## The explanatory statement regarding amendments to GTR No. 6

The following table has been prepared with the detail explanatory statement regarding GTR 6 amendment of proposal from the Republic of Korea.

Transmitted by the expert from the Republic of Korea.

Figure 1. Where and how to measure the opaque obscuration

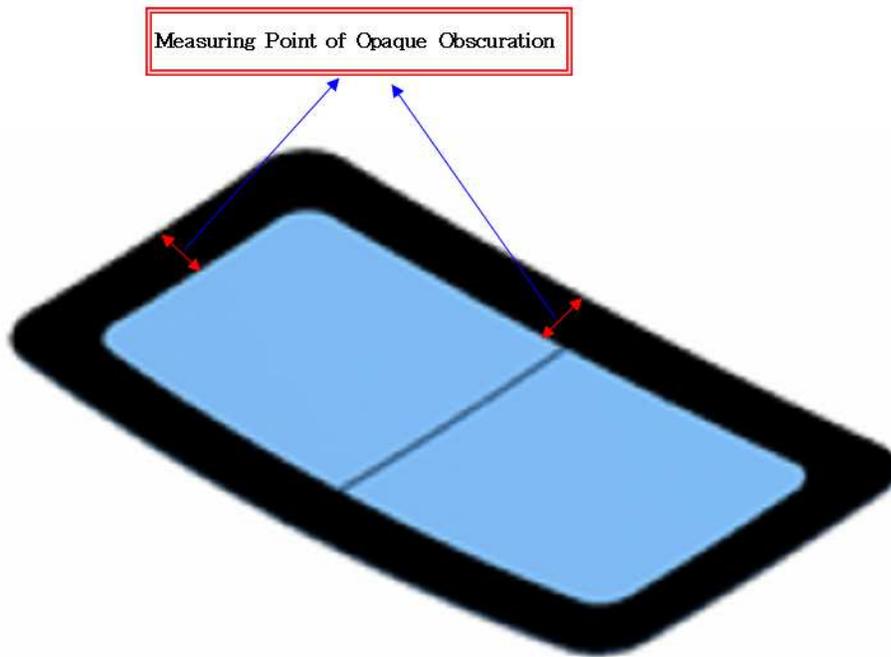
Proposal from the Republic of Korea	Remarks
<p><b>7.2.1.1.2</b> For mounting the glass to vehicle, toughened glass shall incorporate opaque obscuration area no longer than (00) mm from the edge of <del>the designed glass outline</del> <b>the finished product outline.</b></p>	<p>Limited opaque obscuration area from the edge of finished product is allowed for essential reasons such as mounting toughened glass to vehicle. Figure 1 shows the methods to measure the minimal allowable areas of opaque obscuration stated in paragraph 7.2.1.1.2.</p>
<p><b>7.2.1.1.3</b> If two different sheets of toughened glass <del>adjoin each other's edge of designed glass outline</del> <b>the finished product outline, the total width of opaque obscuration area shall be no longer than (000)mm</b></p>	<p>If two sheets of toughened glass adjoin each other like panoramic sunroof, it can be considered as one sheet of toughened glass. In that case, the border of the two sheets of toughened glass becomes the centre of the toughened glass, and there should be some regulation on this. Figure 2 shows how to measure the minimal allowable areas of opaque obscuration stated in paragraph 7.2.1.1.3.</p>
